CITY OF HOBART

City Planning Committee Meeting

Monday, 11 November 2019

7.1 APPLICATIONS UNDER THE HOBART INTERIM PLANNING SCHEME 2015	7
7.1.1 141 Hampden Road, Hobart - Three Multiple Dwellings (One Existing, Two New) Partial Demolition, Extension, Alterations, Landscaping and Alterations to Car Parkng	7

Fig. 20. Proposed car park plan.

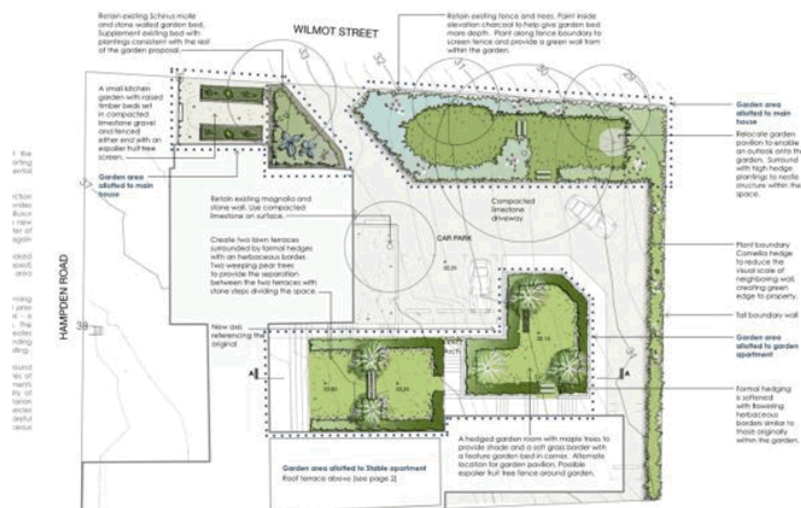
The changes to the car park will result in the loss of the tree adjacent to the title boundary with 12 Wilmot Street.

The proposal removes the existing 12 space car park close to Wilmot Street. The proposed arrangement moves the car park further away from Wilmot Street, reduces it down to three (3) spaces, plus two (2) next to the garden apartment in the corner of the lot, and introduces significantly more landscaping which improves the streetscape and reduces the impact of the car park on the heritage values of the place. Car parking between Melrose and Hampden Road is reduced from three (3) to two (2); however this would mean the loss of some garden space. The Council's Cultural Heritage Officer has recommended refusal of the two new parking spaces at Hampden Road, meaning that the three existing parking spaces would remain, and the front garden retained. The site will therefore have eight (8) spaces rather than seven (7). Because the existing three Hampden Road spaces are already on a hard paved area (a cobblestone drive), this will not change the amount of landscaping in this area, and compared to the proposed two new spaces (which have been recommended for refusal), will actually increase rather than decrease landscaping on the site, and so have a positive heritage and streetscape outcome.

Fig. 22. The two parking spaces (spaces 6 and 7) that are recommended for refusal.

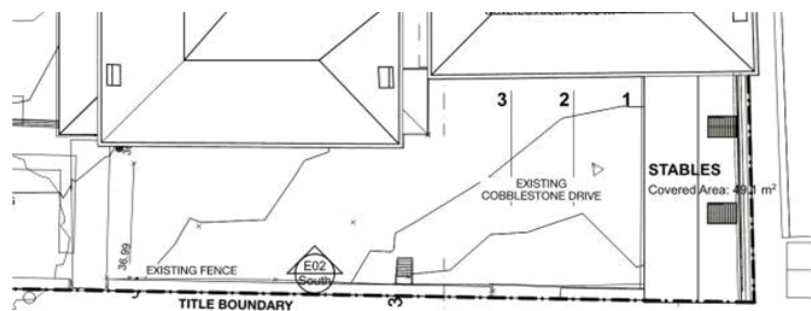
The two parking areas 6 and 7 as shown on plans 1811-DA 14, 15, 16, 17, revisions E and C dated 4/9/19 and 27/8/19 are not approved. The garden area between the 'main building' and Hampden Road must be retained with a new planted garden area between the house and the fence.

Prior to the issue of any approval under the *Building Act 2016*, revised plans, including landscaping plans must be submitted and approved showing the retention of the garden area in accordance with the above requirement.

drawing no 1811-DA15

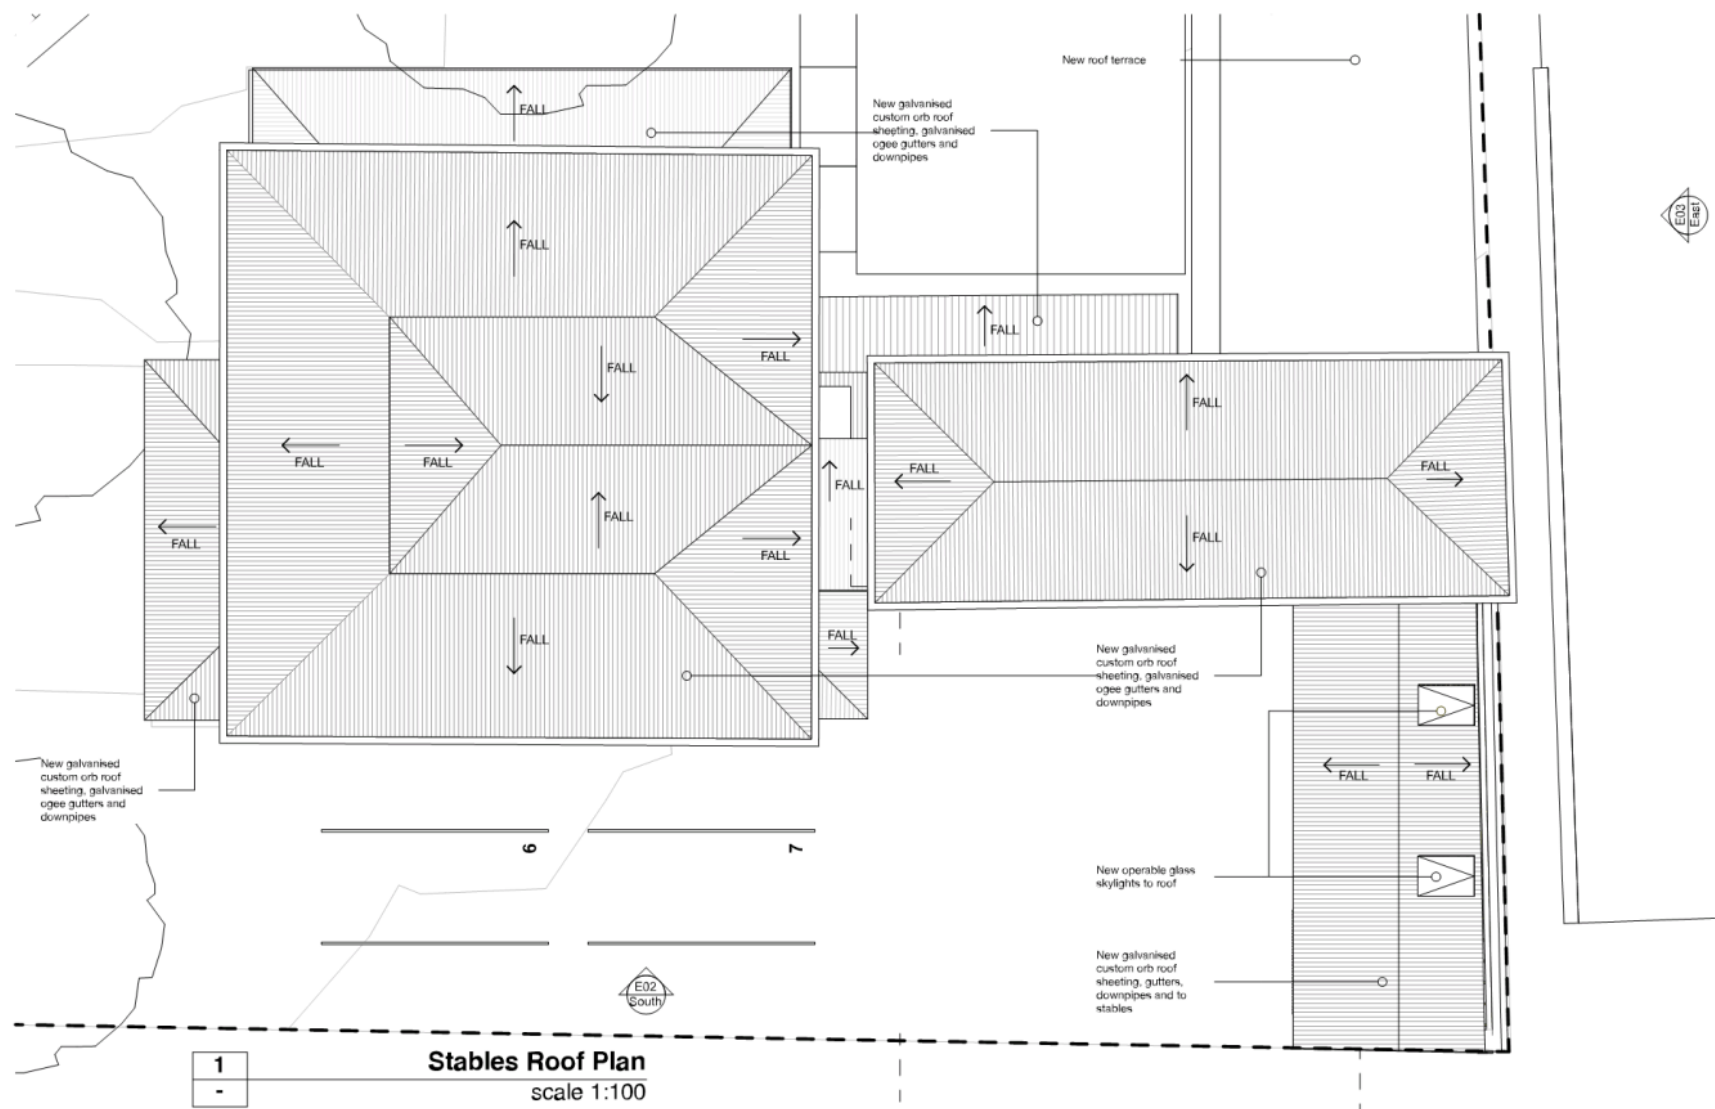
- 1. Jockey parking is permitted as documented on drawing 1811-DA15 Rev C by Circa Morris-Nunn Architects.**
- 2. Manoeuvring area maximum gradient to be 10%.**

SCALE	DESIGNED	DATE	SHEET	TOTAL
1:200	CF	27/08/2019	A1	3
PROJECT NO.	19E99-97	SHEET NO.	C0.01	REV NO.
				1

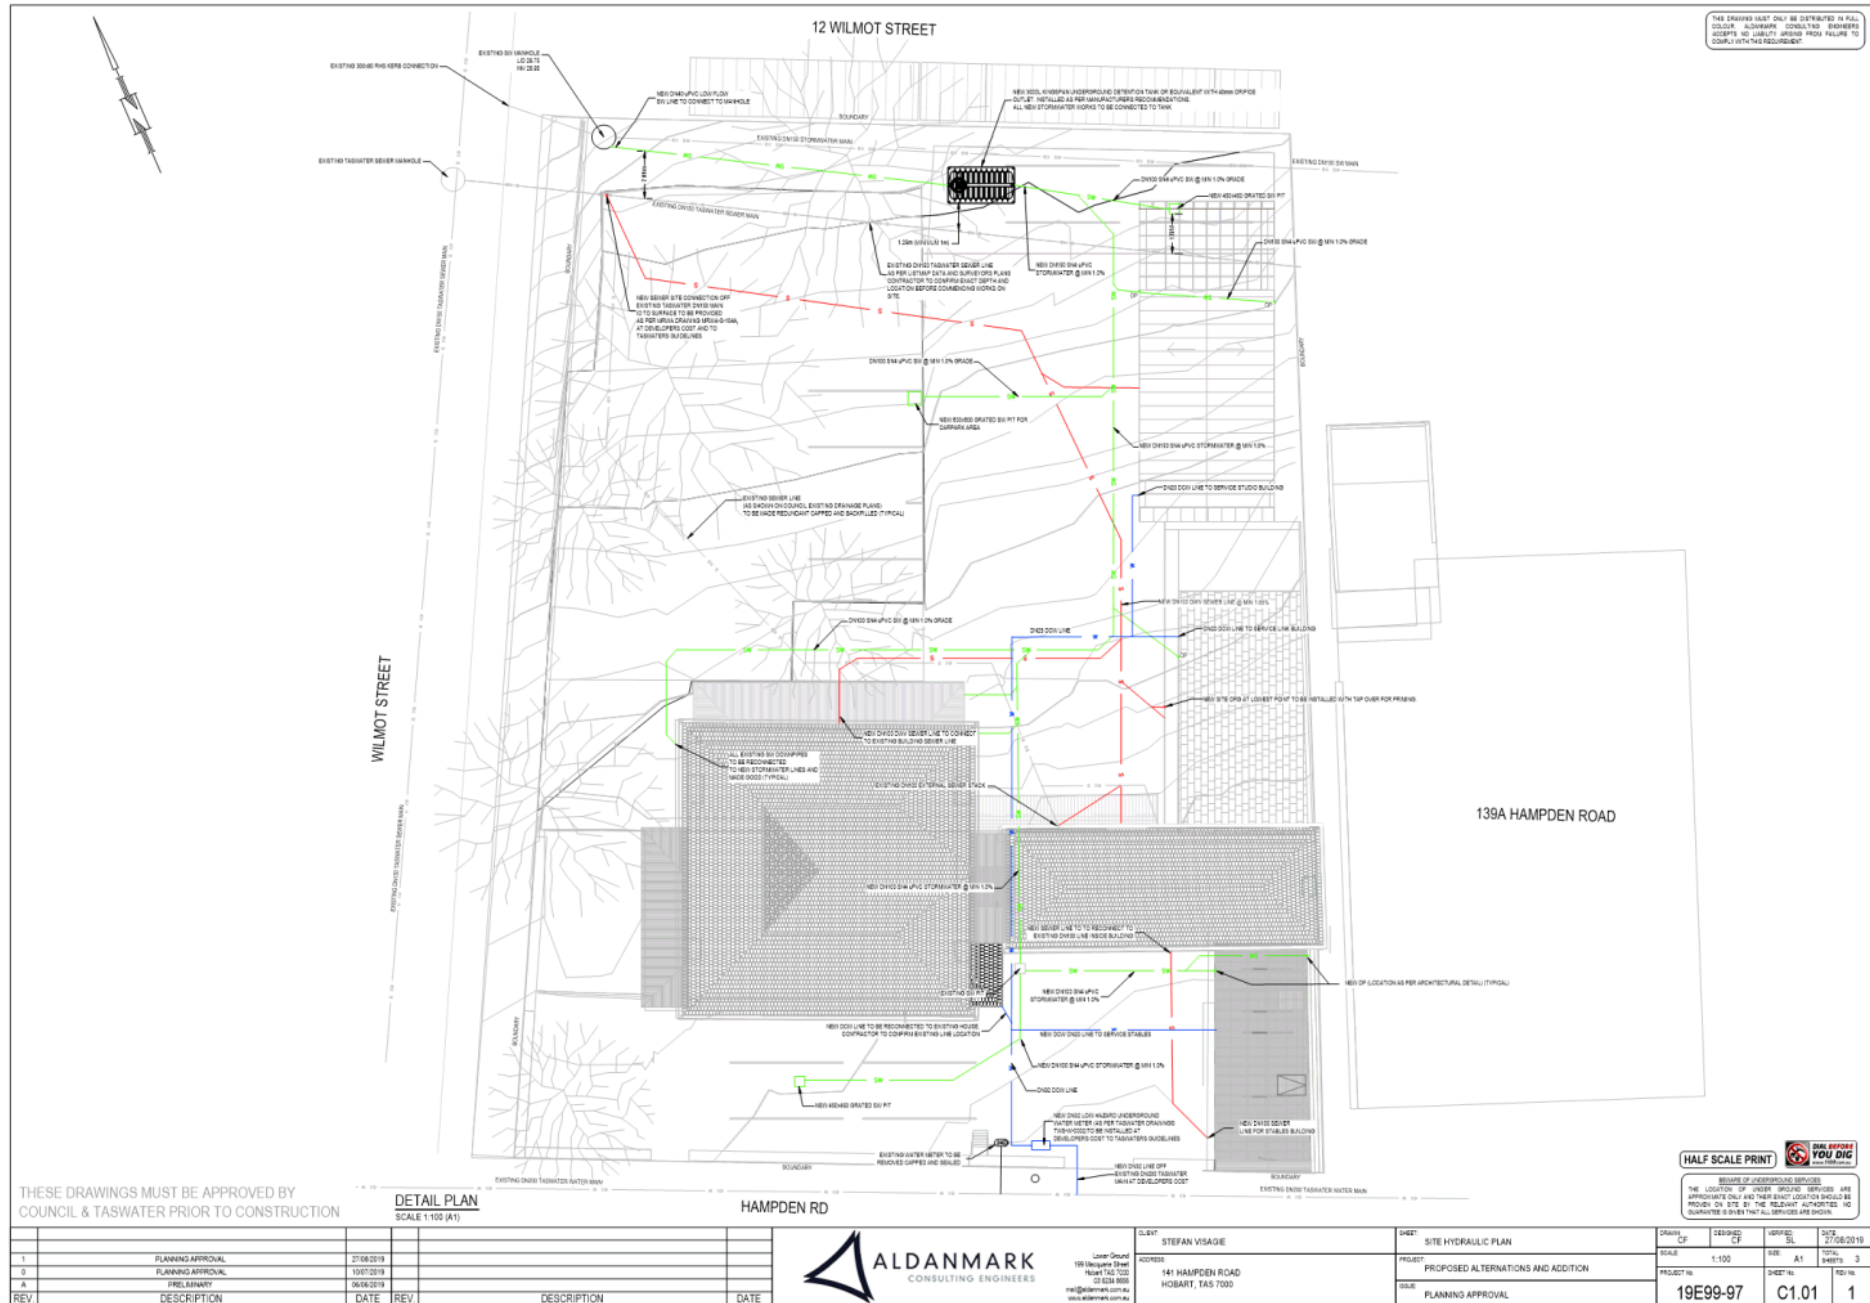
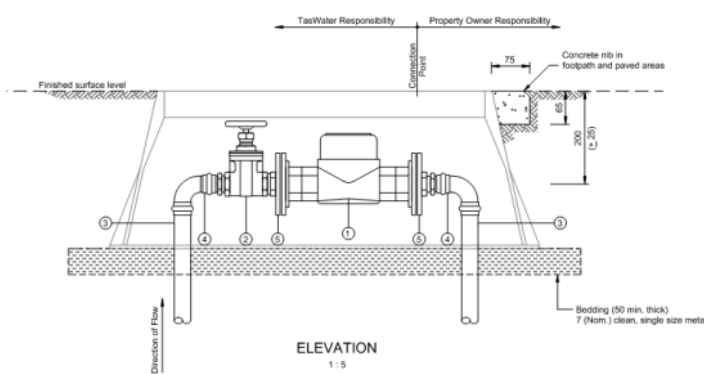
A stormwater detention system in accordance with Aldanmark drawing 19E99- 97 C1.01 Rev 1 must be installed limit stormwater discharges from the development prior to first occupation. The stormwater detention system must have a minimum capacity of 3,000L and a maximum discharge rate of 5 L/s.
